**TOWN OF BROOKLYN  
PLANNING AND ZONING COMMISSION  
Regular Meeting Agenda  
Wednesday, February 3, 2021  
6:30 p.m.**

## ENGINEERING PLAN REVIEW PERTAINING TO 4-LOT SUBDIVISION (ASSESSOR'S MAP 7, LOT 12-1) TRIPP HOLLOW ROAD BROOKLYN, CT (September 5, 2020)

# PROPOSED 4 LOT SUBDIVISION

**Existing Condition Plan**

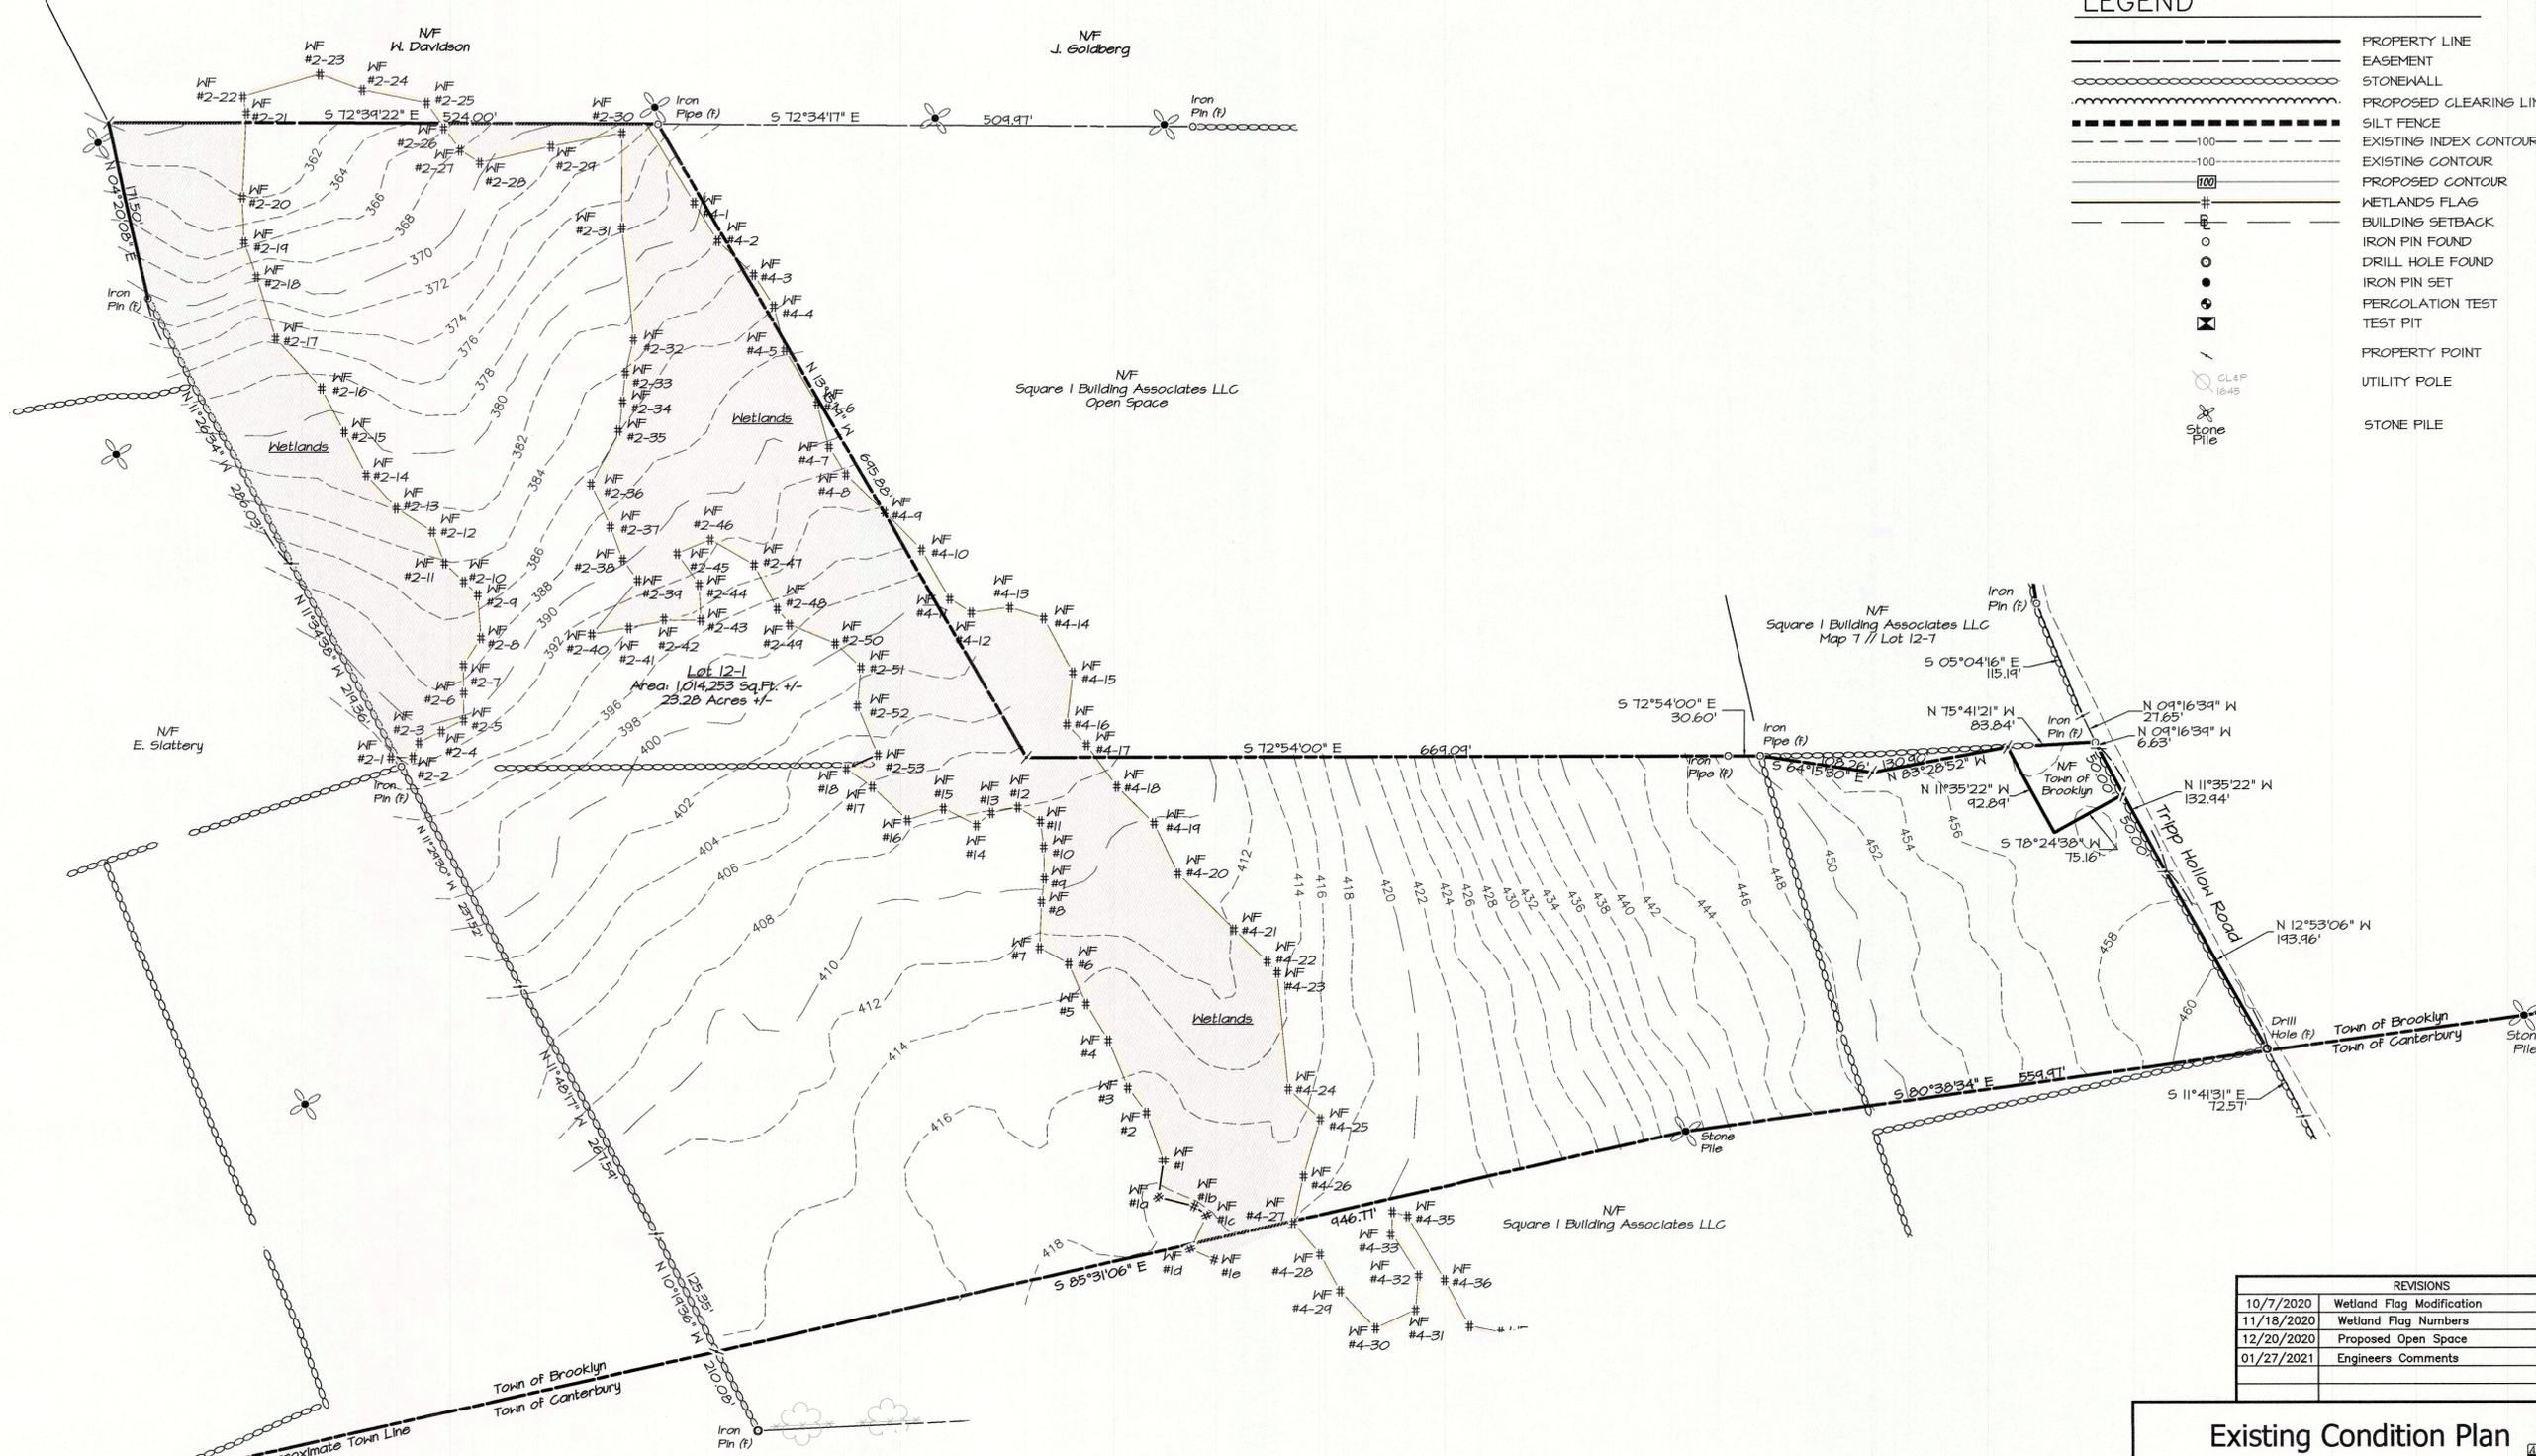
The flag numbering sequence (#2-1-#2-53) on Lot 12-1 was NOT fully corrected and requires a response. The following flags are missing from the plan: 2-4, 2-6, 2-26, 2-34 & 2-41. Flag 2-45 needs its identification number shown.

7. USDA NRCS soil types, with their boundaries, need to be shown on the plan.

- a) Sheet 2 of 8 – Comment 5 – wetland flags have been corrected.
- b) Sheet 2 of 8 – Comment 6 – wetland designation has been added.
- c) Sheet 2 of 8 - Comment 7 – Soil types are shown on Sheet 8.
- d) Sheet 3 of 8 – Comment 3 - The land surveyor has stated that the Town did not require this for the recent adjacent subdivision to the North on the same unimproved Town Road. Town to clarify the need for this as it relates to consistency with the adjacent property.
- e) Sheet 4 of 8 – Comment 1- Silt fence has been added.
- f) Sheet 5 of 8 – Comment 3 - Silt fence has been added.
- g) Sheet 5 of 8 – Comment 8 – Pipe separation information is currently shown in the Driveway Profile Detail on this sheet.

**Subdivision Plan**  
"4 Lot Subdivision"

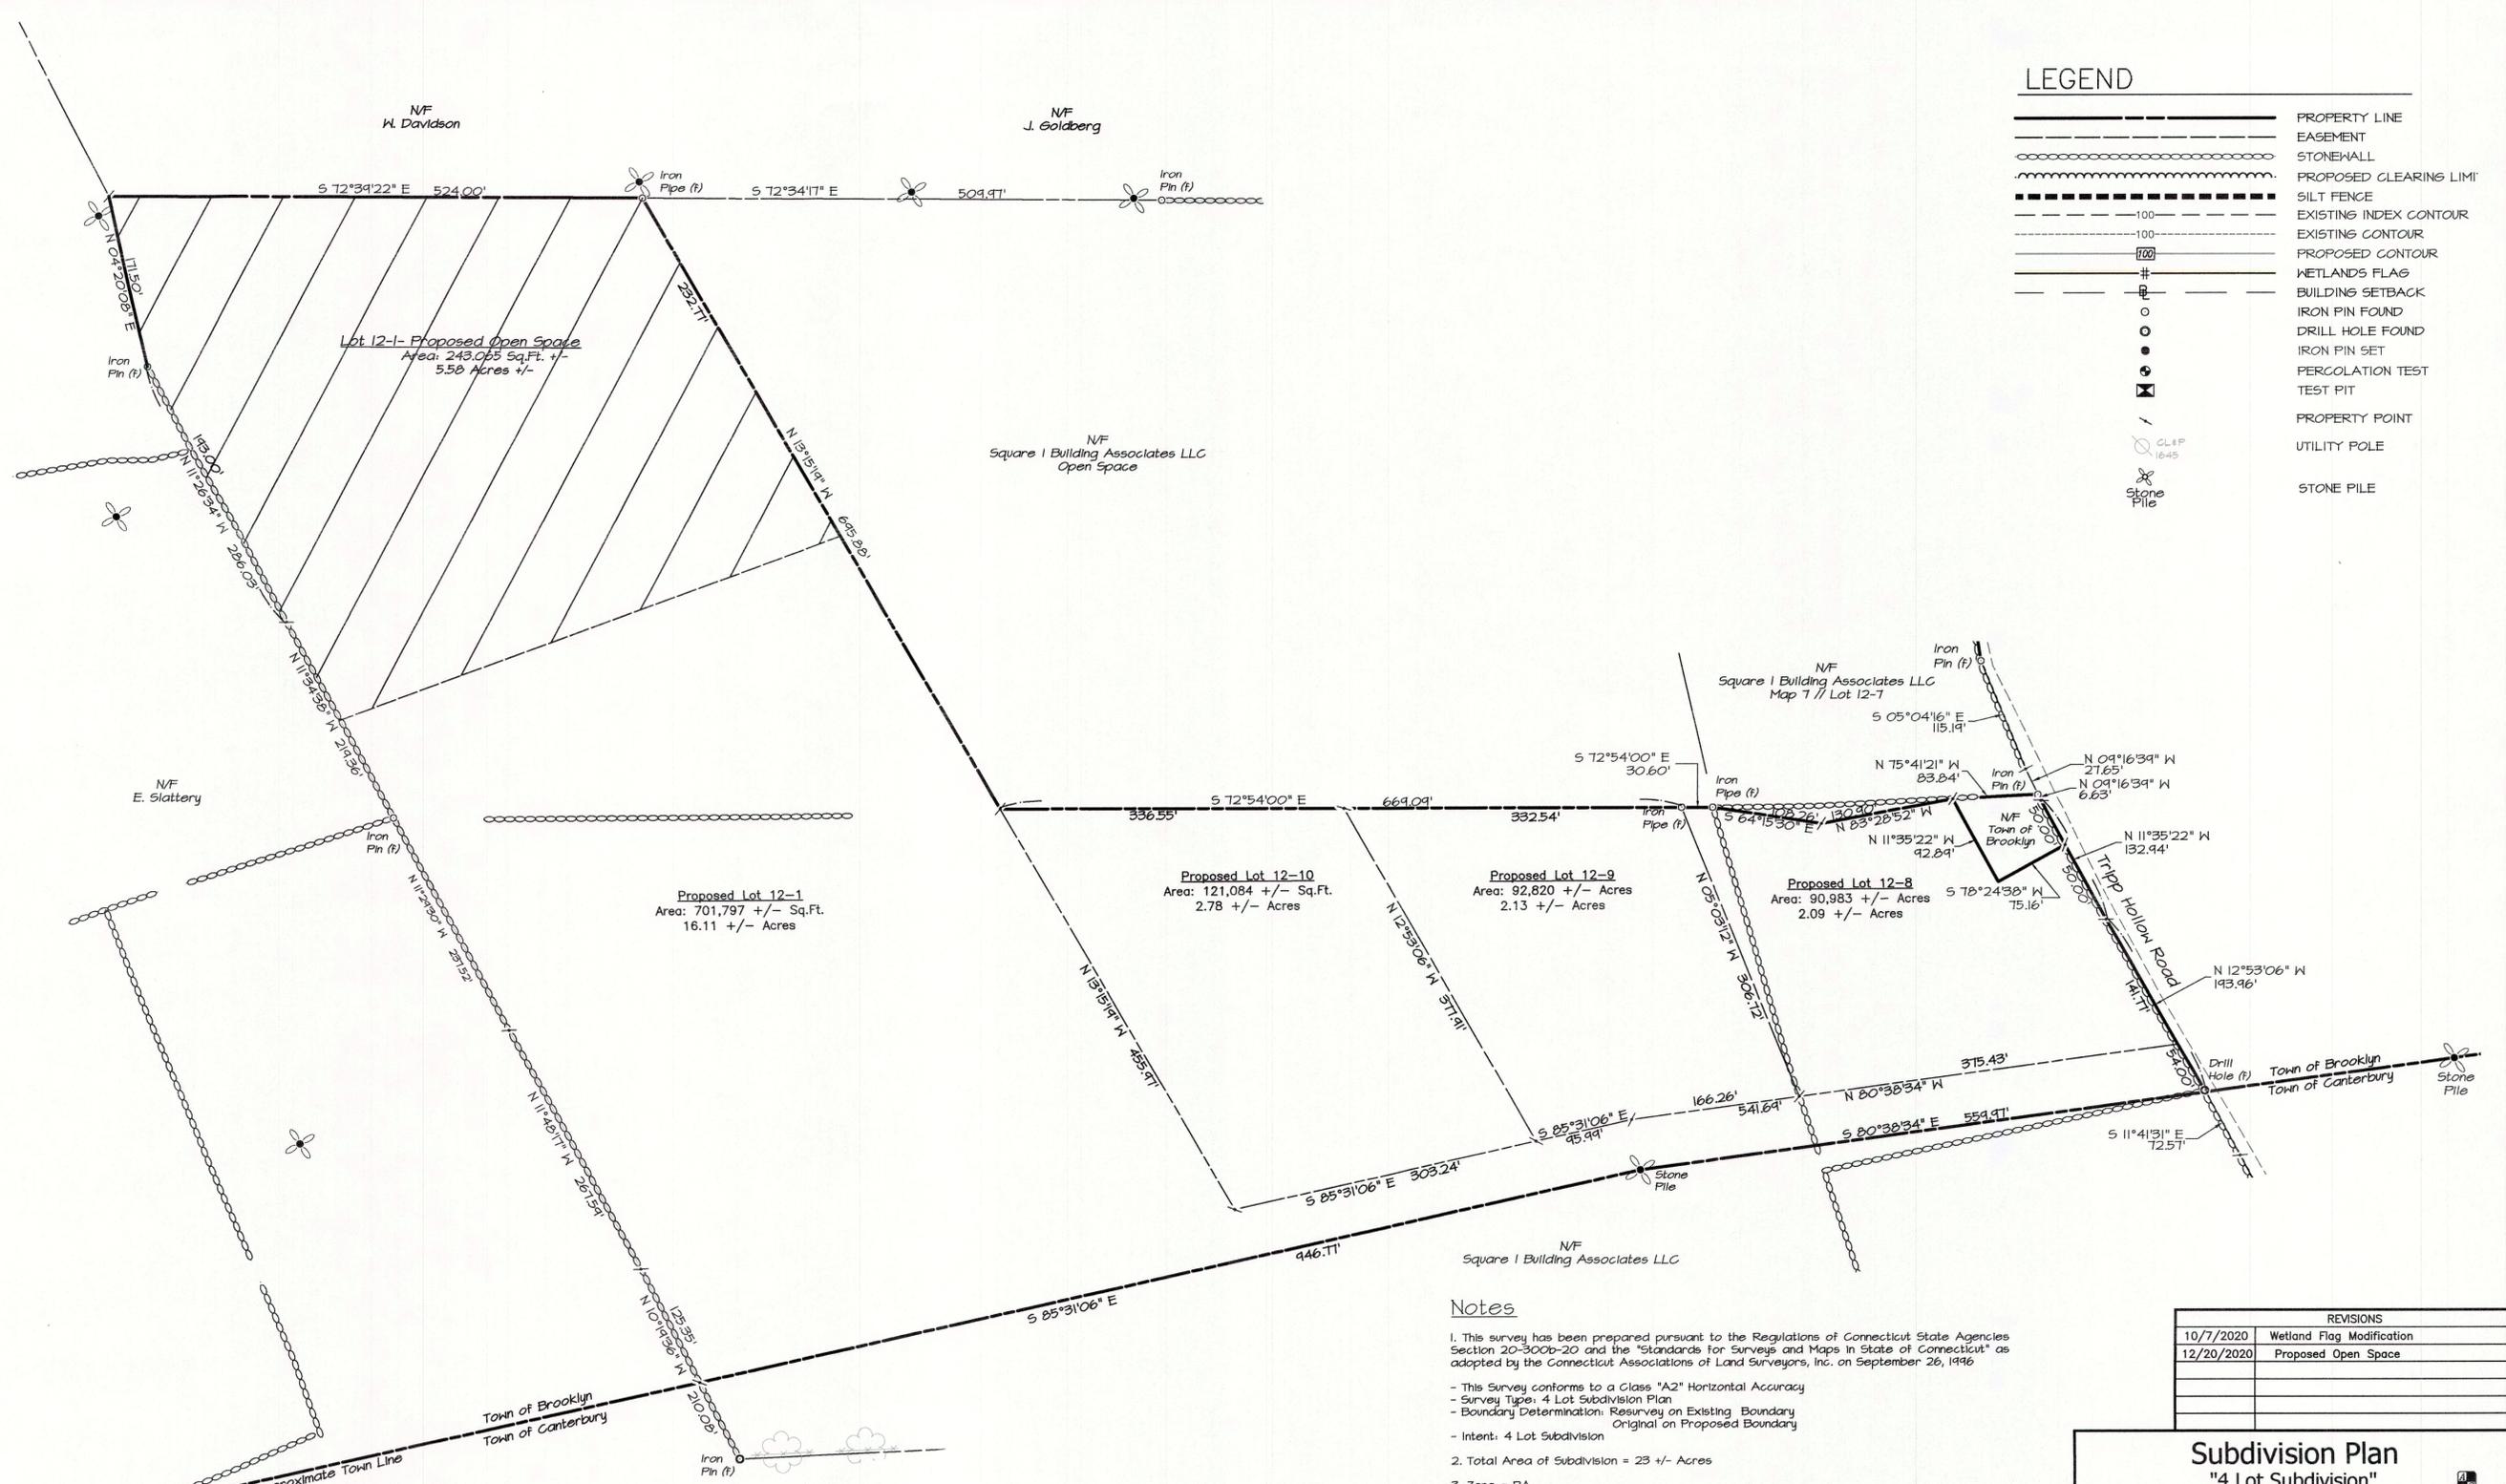
1. Note 6 under "NOTES" states that the parcel is not within 500' of a town line. This note needs to be revised to state that the parcel IS within 500' of a town line (Canterbury). Considering this, have the plans been submitted to the town of Canterbury for review and comment by their respective commissions?

3. The front property line of proposed Lot 12-8 does not appear to be in conformity with Subdivision Regulation 10.6. The first paragraph of this regulation states "*Existing Streets: Proposed subdivisions abutting an existing Town street shall provide for proper widening of the right-of-way of such street to the width appropriate for the classification give such street in accordance with the Town Plan of Development.*" To conform to this regulation, the distance from the centerline of Tripp Hollow Road to the property line needs to be no more than 25' (see Public Improvement Specifications Figure No. 7, "Improvements to Existing Town Roads," on Page 29). The property line orientation in question needs verification by the Applicant's land surveyor and, if necessary, be brought into compliance with the regulation and the lot area recalculated to ensure compliance with minimum lot size.

The Applicant's engineer provided a written response. However, it is not in conformity with Subdivision Regulation 10.6. There is no provision in the Regulations, which I found, allowing the Planning and Zoning Commission to waive or not require this provision. Accordingly, the Applicant is required to meet the requirements of Subdivision Regulation 10.6.

Project No. CLA-6503  
 Proj. Engineer D.H.  
 Date: 08/24/20  
 Sheet No. 4 of 8

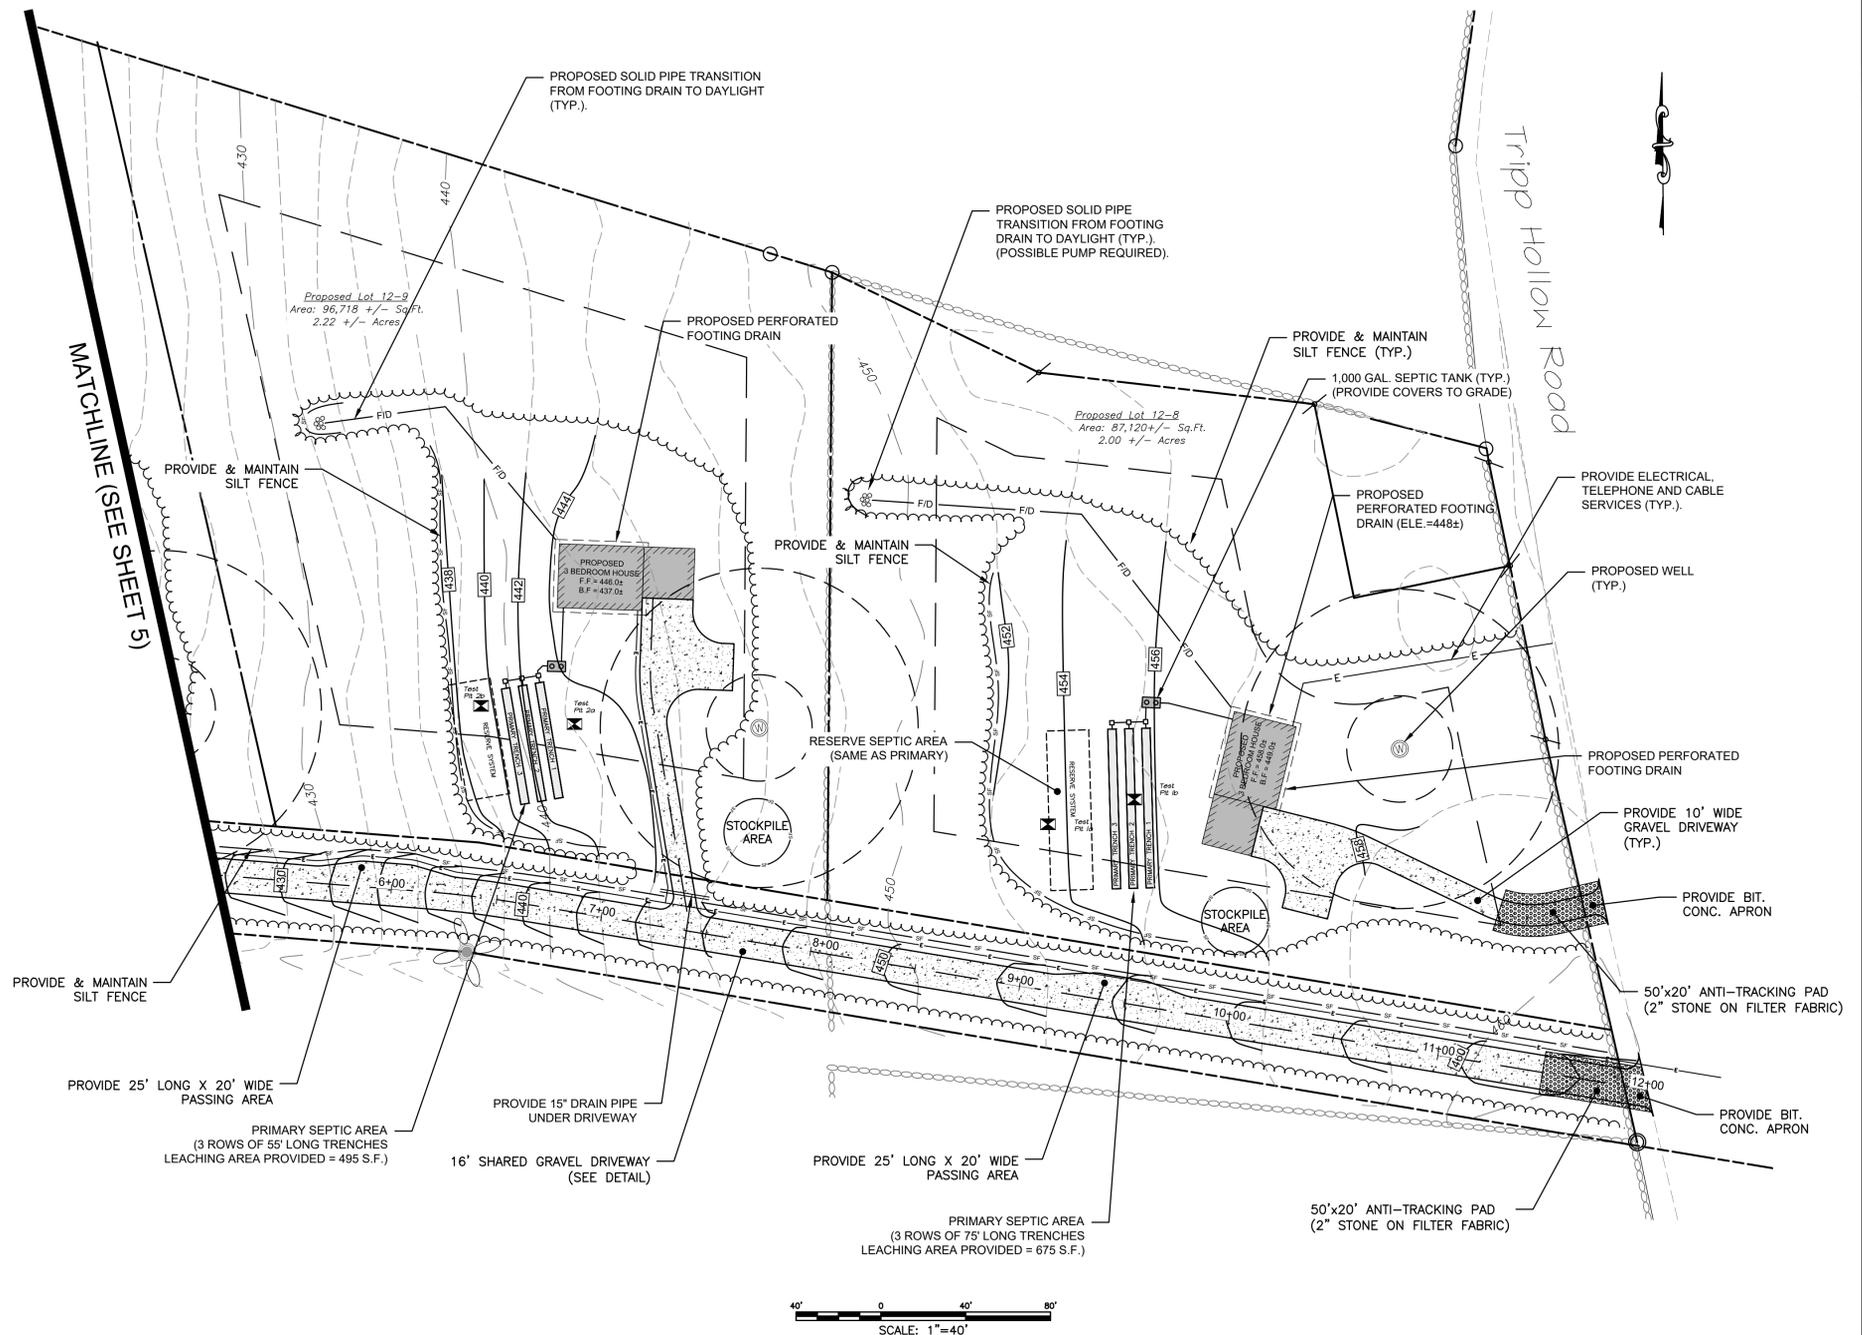
2. How is the entrance to the gravel driveway serving Lot No. 12-9 going to be protected from erosion caused by runoff from the common driveway, which is shown to have a 4% grade toward this driveway? From proposed grading and existing contour lines depicted on the plan it appears that the flow could become a shallow concentrated flow during heavy storm events and cause soil erosion.

**This comment has been addressed and no further response is necessary.**
